SERVICE No-351 BULLETIN

Piper Aircraft Corporation

Subject: Fuel Line Replacement

Models Affected: PA-20-115, PA-20-125, and PA-20-135 Pacer
PA-22-108, PA-22-125, PA-22-135, PA-22-150, PA-22-160
Tri-Pacer

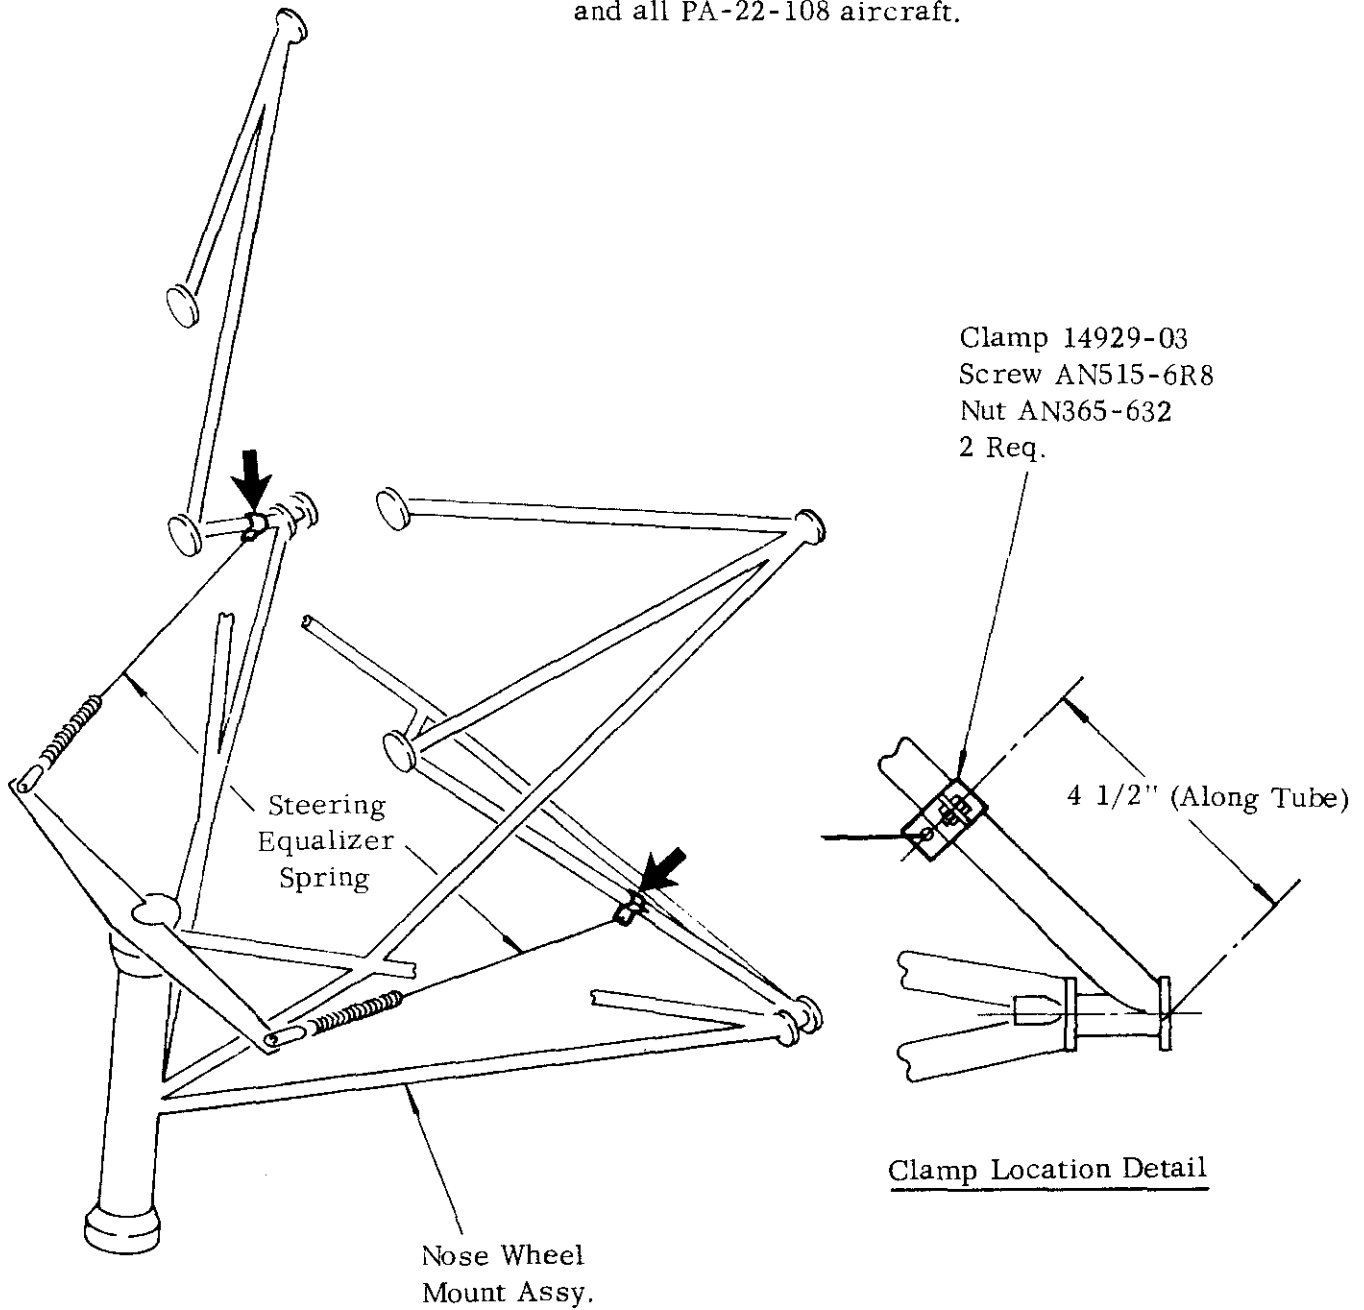
1. When replacing original fuel line assembly, Piper part number 70322-32 with newer type fuel line assembly, Piper part number 17766-66, installation kit Piper part number 754 439 is also required (one each per aircraft) @ suggested unit retail price \$1.73C.
2. When replacing the originally installed Piper part number 70322-32 flexible fuel line with the new flexible fuel line, Piper part number 17766-66 on all utility category PA-22-150 and PA-22-160 Tri-Pacers and on all PA-22-108 Colts, serial numbers 22-8000 and up, in addition to the installation kit referenced in Note 1, above, two (2) each clamps Piper part number 14929-03 are required (see sketch on page 3 of this bulletin) @ suggested unit retail price \$4.06.

Install clamps 14929-03 as shown on all utility category PA-22-150 and PA-22-160 aircraft and all PA-22-108 aircraft.
